Appendix	F
SRPRS	19.046
File(s)	D01-14003 D02-14014

**Re: Proposed Official Plan Amendment
Moderno
11488 Yonge Street and 49 Gamble Road
Town File Nos.: D01-14003 and D02-14014
York Region File No.: LOPA.18.R.0037**

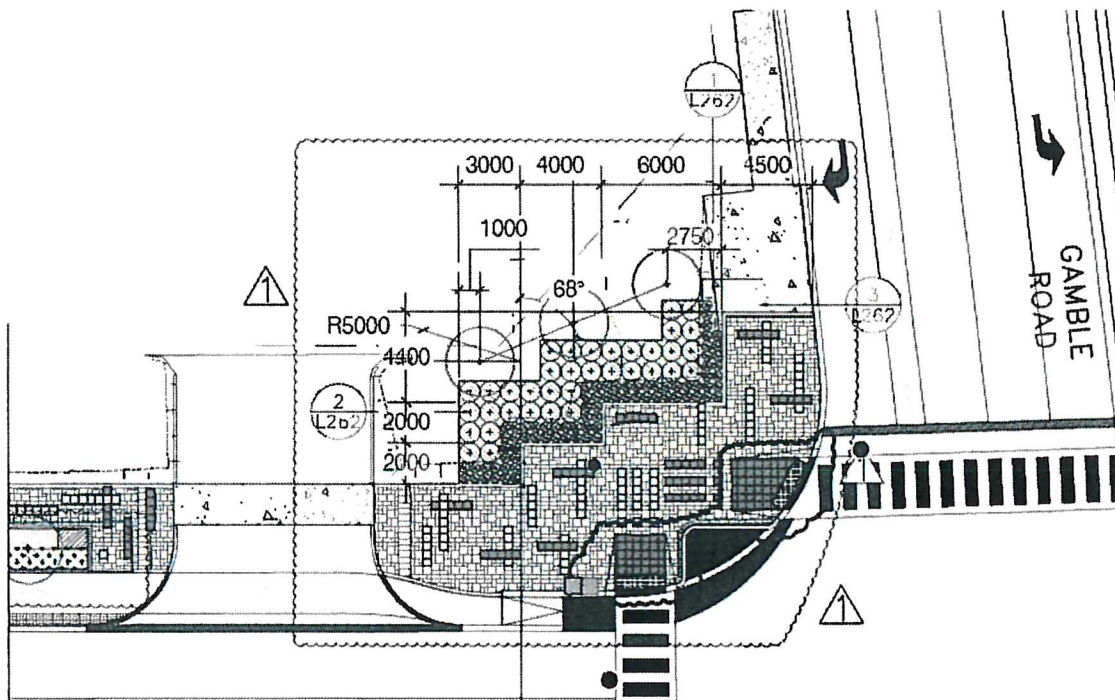
- 1.1. The proposed development concept and Transportation Study shall be revised to demonstrate that the proposed easterly access onto Gamble Road will be restricted to right-in/right-out operation only and enforced by extending the median on Gamble Road to the west. This requirement is based on the following assessment:

- a) The proposed easterly driveway is located approximately 52m from the stop bar of the Yonge Street/Gamble Rd/19th Ave intersection. This is under the assumption that the location of the existing driveway to Gamble Rd will be maintained similar to the existing conditions. However, given the Region is currently constructing the rapidway on Yonge Street and this intersection will be reconstructed, this distance will be much shorter and the proposed access will be significantly impacted and blocked by the queues on Gamble Road.

- b) Based on the Transportation Study, Table 5.1 indicates that the existing eastbound right-turn queue (approximately 90 m) will block the driveway during the peak periods. This will prevent vehicles from making left turns in and out of the proposed development. This blockage will also create turning movement conflicts and sightline issues for drivers, which will result in frequent accidents and operational problems.

- c) The proposed development does not demonstrate that the westbound left-turn at the easterly access will be provided a dedicated left-turn lane into the site. In the absence of this exclusive westbound left turn lane, the

westbound left turn traffic into the site will block the westbound through lane on Gamble Road. This is not acceptable to the Region.

- 1.2. For the condominium component to the east, the proposed development concept shall be revised to demonstrate that the concrete median on Gamble Road at the Yonge St/Gamble Rd/19th Ave intersection will be extended westerly to enforce the right-in/right-out access operation onto Gamble Rd.
- 1.3. The proposed access onto Gamble Road cannot be located within the taper portion of the eastbound exclusive right turn lane, the existing eastbound exclusive right turn lane shall be extended further to the west to accommodate the proposed right-in/right-out access onto Gamble Road within the parallel section of the eastbound exclusive right turn lane.
- 1.4. It should be noted no access will be permitted on Yonge Street for the easterly development.

- 1.5. For the townhouse development component to the west, the proposed development concept shall be revised to demonstrate that access will be provided through Royal Chapin Crescent, to the south. No access will be permitted onto Gamble Road. The Transportation Study shall be revised to reflect this requirement.
